Product Change Notification

MULTIFUSE® PPTC RESETTABLE FUSES

Bourns® Radial Leaded Multifuse® Polymer PTC Resettable Fuses

Changes to Tape and Reel Packaging

MF1818

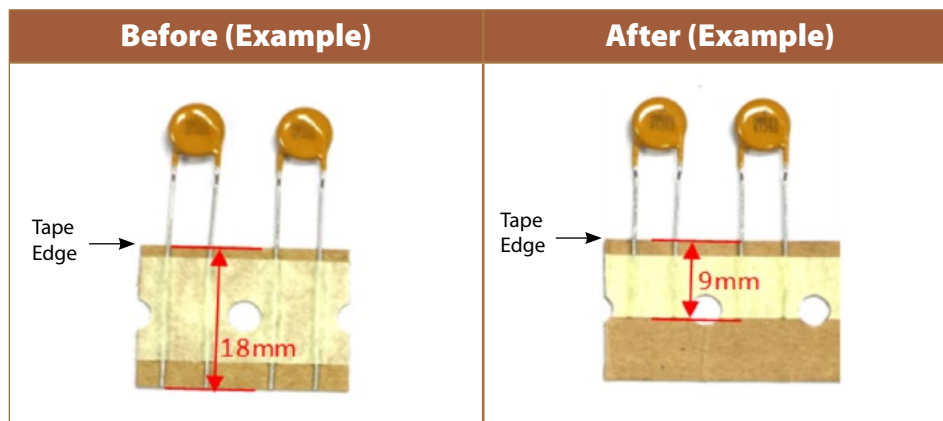
Lead Length Scrap Reduction

For the Multifuse® models listed in the “Affected Part Numbers” table in this PCN, the total length of the leads will be shortened as shown in the example pictures below. The actual dimension changes will vary between models. However, assuming the components are removed from the tape and reel packaging by cutting the leads at the tape edge, the form, fit and function of the components are not affected. Only the length of the scrap lead material remaining in the tape will change. There is no change in the mechanical, electrical or material properties, and the components’ performance and agency recognition remains the same. Changed products can be identified by date code according to the implementation timeline outlined in this PCN. Samples are available upon request.
